Prototypes

Through a series of 3D models and client feedback I overcame material and manufacturing issues while staying true to my original design.

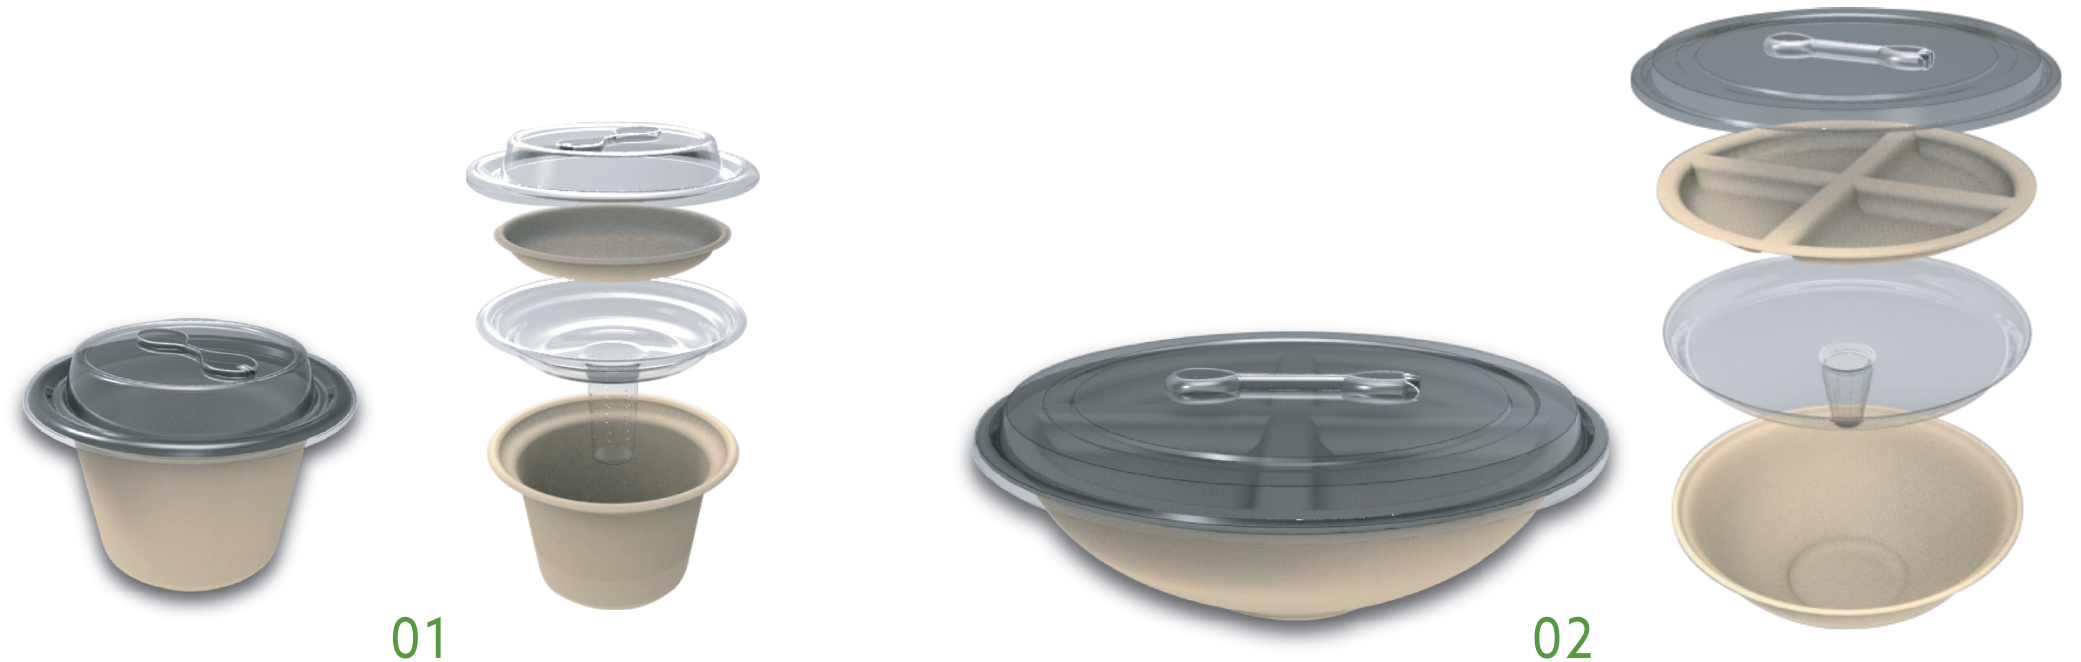
To much material
in ice holder.

Condiment holder **doesn't**
need that much support.

Die-Cut utensil
will have a sharp edge.

Slots on the condiment
holder will **make it easy to**
remove.

Having to **remove the ice**
tube could be messy.

To steep of a draft
on the ice tube.

The folding utensil will still
have a sharp edge.
